Collective amendments to Regulations Nos. 16, 44, 94, 129 and 137

Submitted by the expert from the European Commission*

The text reproduced below was prepared by the expert from the European Commission to harmonize information in the airbag warning label on the correct installation of Child Restraint Systems (CRS) on a passenger seat with activated frontal airbag. The modifications to the current text of the UN Regulations are marked in bold for new or strikethrough for deleted characters.

Figure 5

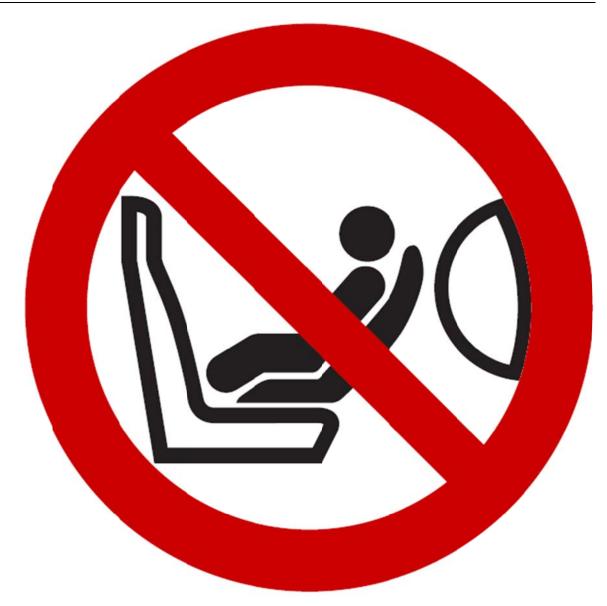
The overall dimensions of the label shall be at least $120 \times 60 \text{ mm}$ or the equivalent area.

The label shown above may be adapted in such a way that the layout differs from the example shown here above; however, the content shall meet the precise above prescriptions. Furthermore, no other type of information shall be included on the label unless it is placed outside a clearly marked

rectangle with at least the overall dimensions as required above. In derogation to the aforementioned, a part number, bar code or similar identification mark not exceeding 5 mm x 20 mm or the equivalent area may be placed on the label alongside one of its edges.

It shall also be ensured that no deviations in the shape and orientation of the provided pictograms are permitted, notably that any customised appearance of the prescribed pictogram images shall be prohibited, with the exception of the hand with pointing index finger and the open face booklet with letter 'i' on its right page provided that they are clearly recognisable as such.

Small irregularities concerning line thickness, label imprinting and other relevant production tolerances shall be accepted.
